Stage 03: Workgroup Report

Grid Code

GC0101: EU Connection Codes GB Implementation – Mod 2

This document contains the discussion of the Workgroup formed in June 2017, responses to their consultation and the Workgroup's final conclusions.

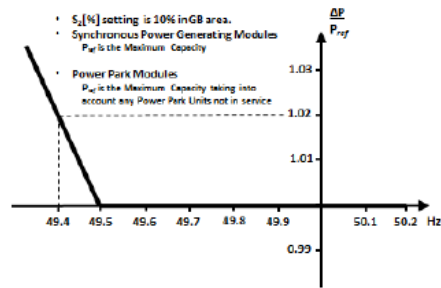
The figure X2 has a small note stating that the response for a power park module is based upon the number of power park units in service.

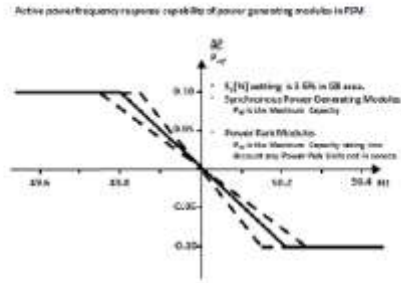
<p>The figure X3 has a small note stating that the response for a power park module is based upon the number of power park units in service.</p> <p>Windfarm manufacturers believed the windfarm operators and OEM's had the freedom to choose central or power park unit based frequency response (ECC6.3.7.3.1)</p> <p>With the advantage that a module approach would give the response based upon the available active power in the wind regardless of the unit available and not the number of WTG's in service.</p> <p>The unit approach enables the windfarm to decrease the power output when units are out of service.</p> <p>Now however it appears in the figures that there is no distinguishing between either approach. If it were treated as a module with a central controller the windfarm must de-rate the remaining available power to represent the loss of a unit in service.</p> <p>Finally The module approach has significant available capacity advantages over most of the operating range. Which would (with the Unit approach) have to be supplied by conventional or legacy generation, at extra cost. Surely there is a cost benefit advantage from the module</p>
